**167 Northumberland Street,
Liverpool**

Traffic Impact Assessment

Issue | 11 May 2021

Figure 9 Parking Layout – Basement Level 3

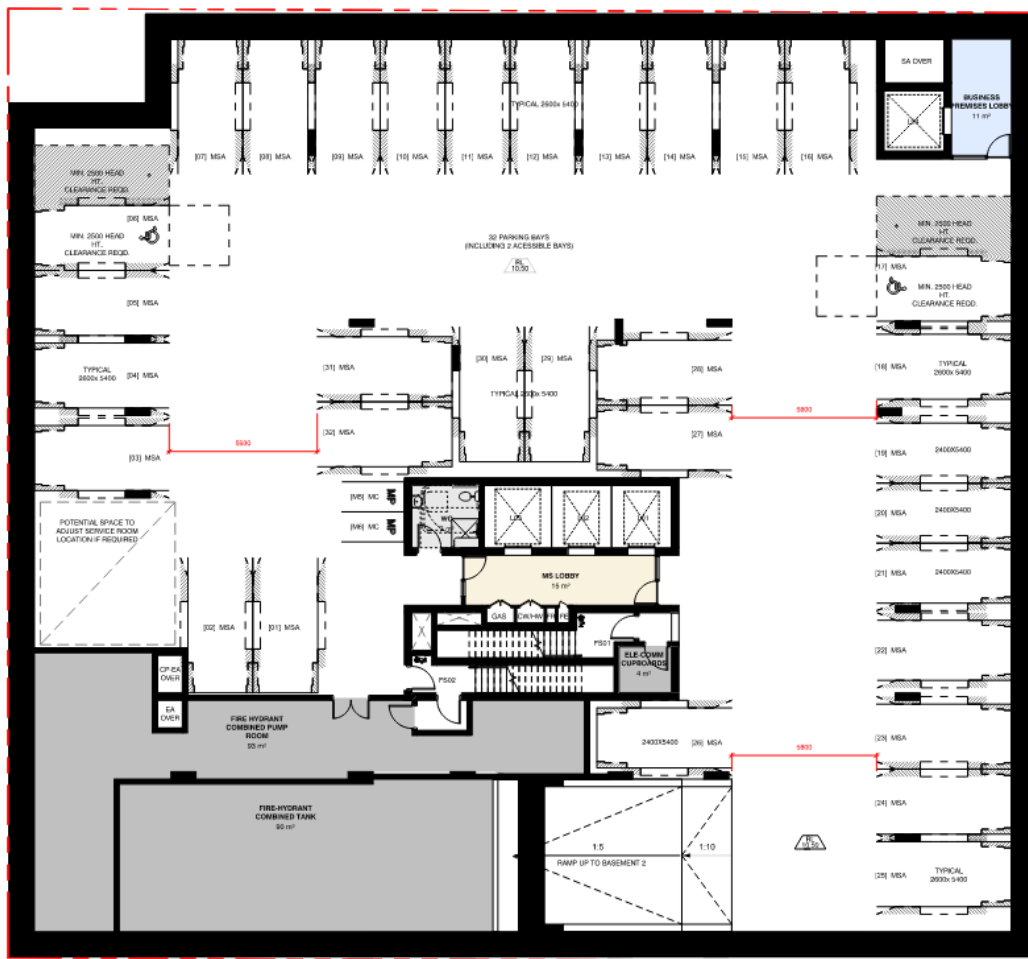
6.	The Section 6.2 of the RtS only provides the requirement of accessible parking space provision. However there is no assessment being undertaken to identify if the adequate accessible parking spaces are provided on site.	<p>21/04/21</p> <p>Accessible parking spaces are illustrated in Figures 7 and 8 of the report. Currently proposed 2 accessible carpark spaces per basement.</p> <p>11/05/2021 Additional basement level (L3) has been incorporated to the project. Refer to Figure 9</p>
